SERVICE BULLETIN

DATE: 23 NOVEMBER 1983

INSTALLATION OF COLLECTIVE STICK SUPPORT BRACKET REINFORCEMENT STRAP

All 500 Model 369H, 369HE, 369HM, and 369HS Series Helicopters.

Figure 1. Installation of Collective Stick Support Bracket Reinforcement Strap

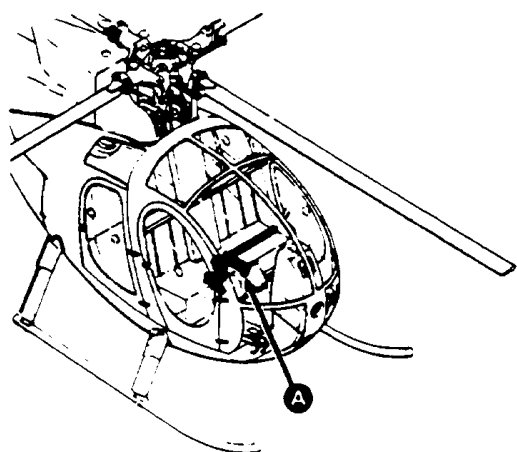
NOTE: Insulation on some production strap assemblies, PN 369ASK806-3, covers the entire strap. The insulation material must be removed from each end of the strap to one inch inboard prior to installing the strap. To remove this material, cut the unwanted portion from the strap using a plastic knife or similar instrument. Use care when cutting the insulating material. If the strap is scratched or nicked, it must be replaced.

- (4). Install strap with new bolts, washers, spacers, nuts, and retained washers as shown in Figure 1.
- (5). Ensure that strap is tight with bolts torqued by shimming with new washers as required. (See Figure 1.)
- (6). Use over-center action of collective stick to remove load from bungee tool and remove tool from bungee spring. (Refer to basic HMI, Section 7.)
- (7). Reinstall pilot's seat cover and controls access door. (Refer to Basic HMI, Section 2.)
- (8). Record compliance with this Service Information Notice in Compliance Record of helicopter Log Book.

1. REINSTALL EXISTING WASHERS UNDER BOLT HEAD AND BETWEEN SPACER AND NUT.
2. EDGE OF BUSHING MUST PROTRUDE MINIMUM 0.010 IN. TO MAXIMUM OF 0.080 IN. ABOVE OUTSIDE SURFACE OF PART AFTER NUT IS TIGHTENED.
